Marandoo Mine Phase 2

Hamersley Iron Pty Ltd

**Report and recommendations
of the Environmental Protection Authority**

**Report 1355
April 2010**

Figure 4: Drawdown in the Unconfined Aquifer

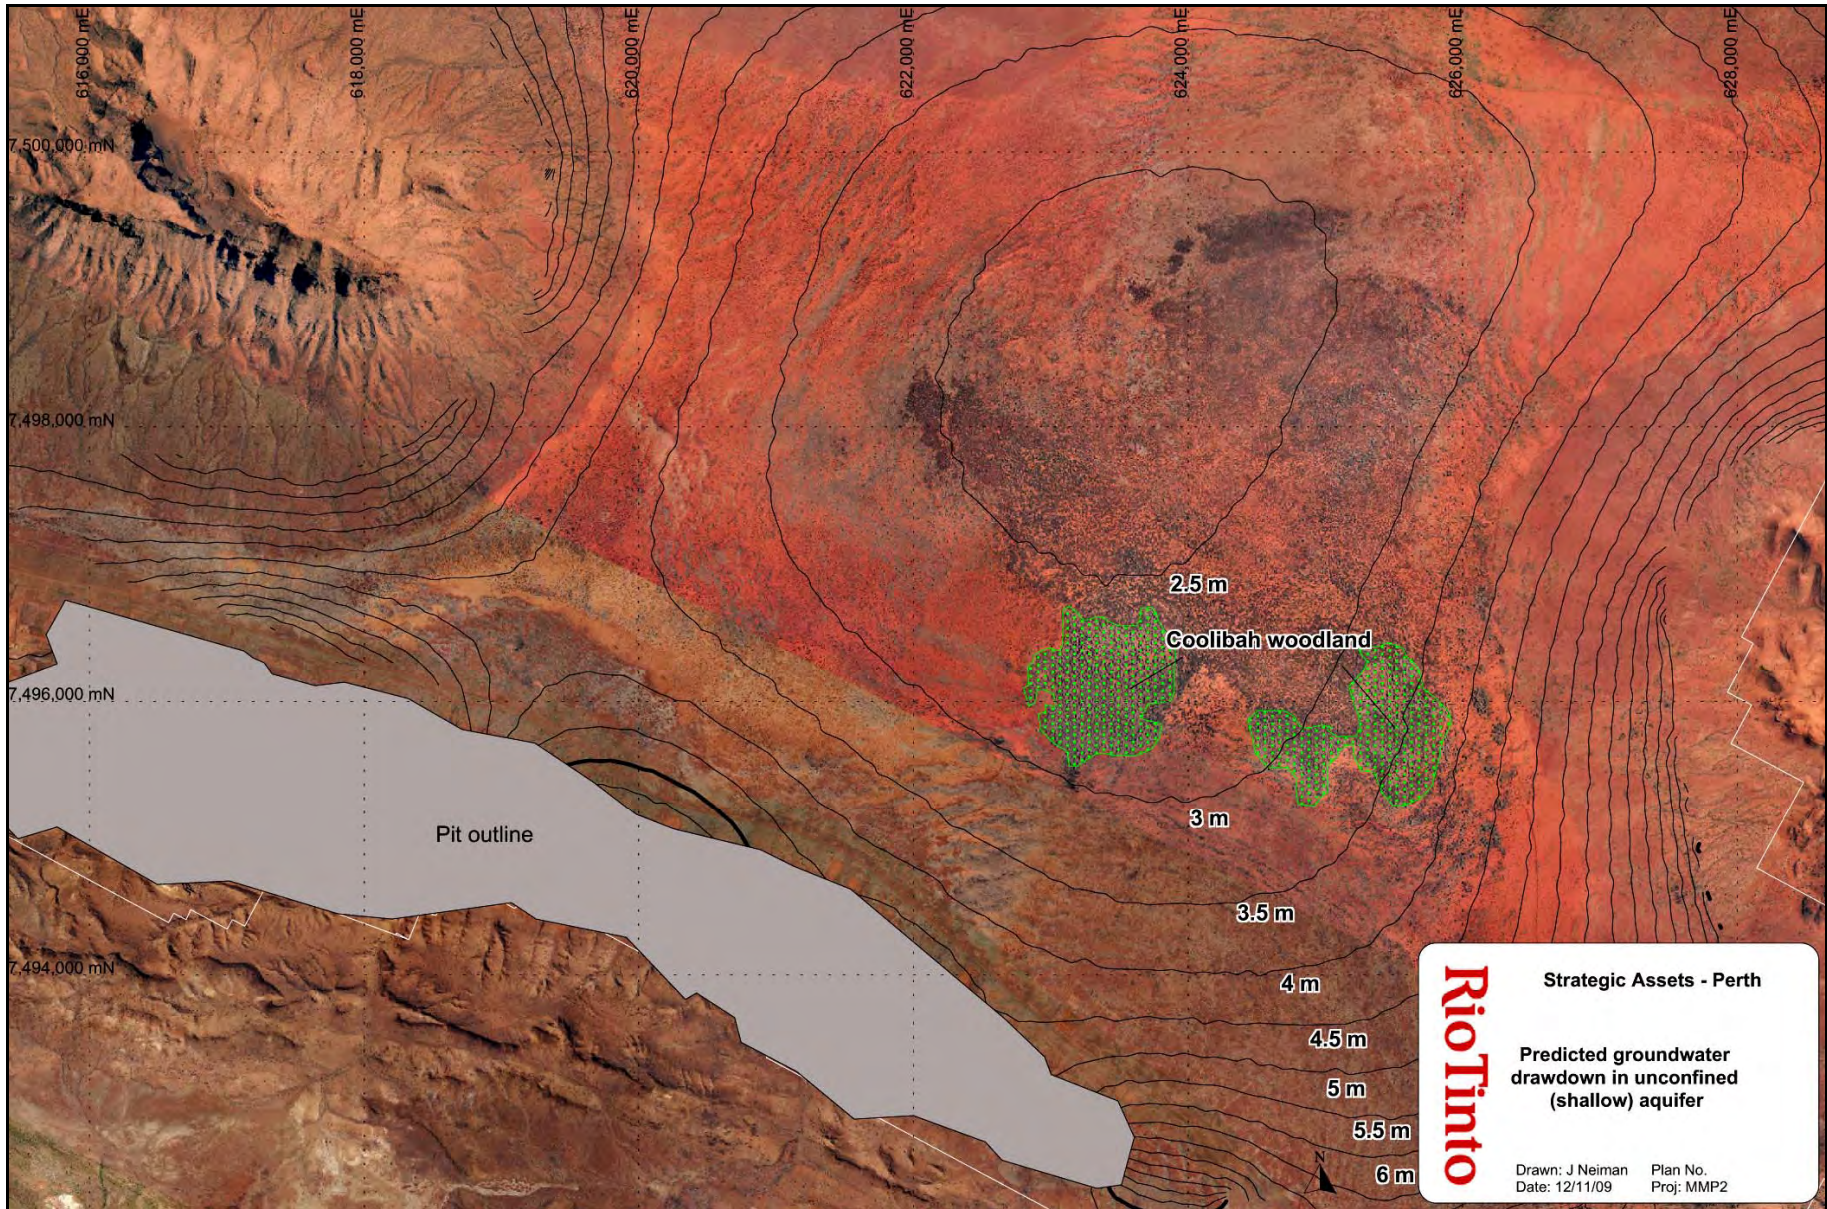
The proponent has carried out extensive hydrogeological investigations and modelling at Marandoo. The unconfined aquifer receives the majority of its recharge in the area of the Coolibah Woodlands on Mount Bruce flats (MWH, 2006). Groundwater flows radially outward from the resulting groundwater mound. The proponent's modelling predicts that seepage into the mine pit would result in drawdown beneath the Coolibah Woodlands of 2.5m to 4m over the life of the mine (Figure 4).

The EPA notes that, should the Coolibahs be entirely dependant on groundwater, given the slow rate of the predicted fall of 2.5 to 4m over a period of 21 years, the required rate of root growth to keep up with the change in ground water would be 0.5mm per day, and that this appears to be within the capabilities of *E. Victrix* (Batini, 2009).

Figure 5: Location of discharge point

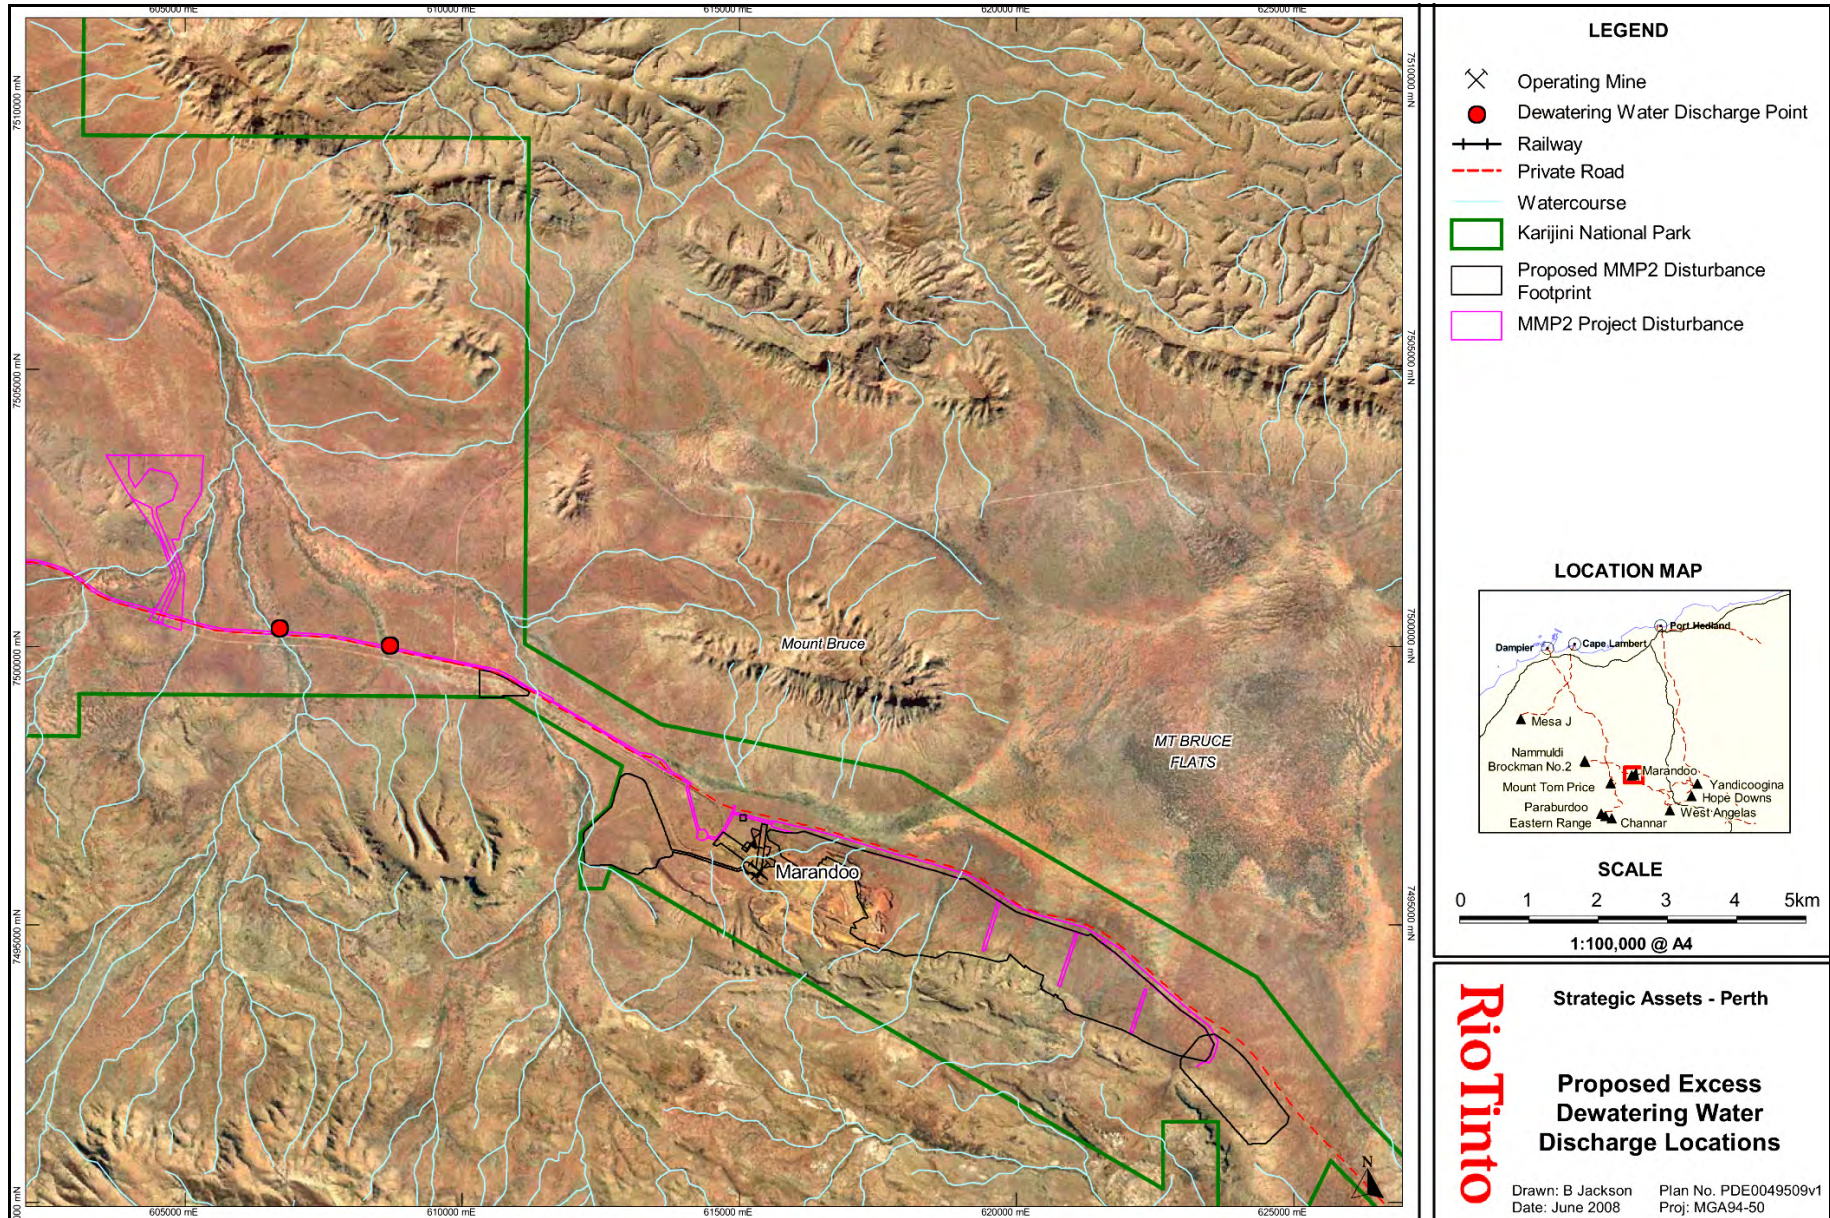
The proponent has nominated two discharge points within the mine lease (Figure 5). An assessment of the condition of flora and vegetation downstream of the proposed dewatering discharge locations was undertaken in July 2008 by Matiske, consisting of collection of specimens along 18 transects, and visual evaluation of stress in

The discharge points are located approximately 5 kms upstream of areas within the 2015 Exclusion Zone. This is an area of Hamersley Station which is designated to become part of the Karijini National Park in 2015, and is considered to have high conservation significance. The proponent estimates that dewater could travel approximately 20 km along the drainage lines and is therefore likely to encroach into the 2015 Exclusion Zone.

The Hamersley Themeda Grasslands are a Threatened Ecological Community which occurs 26 kms downstream of the discharge points. The proponent considers that it is highly unlikely that dewater would travel more than 20 kms along the discharge channels.

Discharge of excess water into the tributary of the Southern Fortescue River is likely to have negative impacts as these features typically support episodic drainage and the associated plant communities are unlikely to withstand inundation for more than a few weeks.

- (d) that there is a TEC located approximately 26kms downstream of the dewater discharge point. The proponent shall ensure that dewater discharge does not extend more than 20kms along the designated discharge channels and that there is no increase in the variety or distribution of weed species as a result of dewater discharge;
- (e) that the proponent shall ensure that sinkhole formations attributable to the proposal are detected in a timely manner and managed appropriately; and
- (f) that closure and rehabilitation activities shall be planned and implemented appropriately.
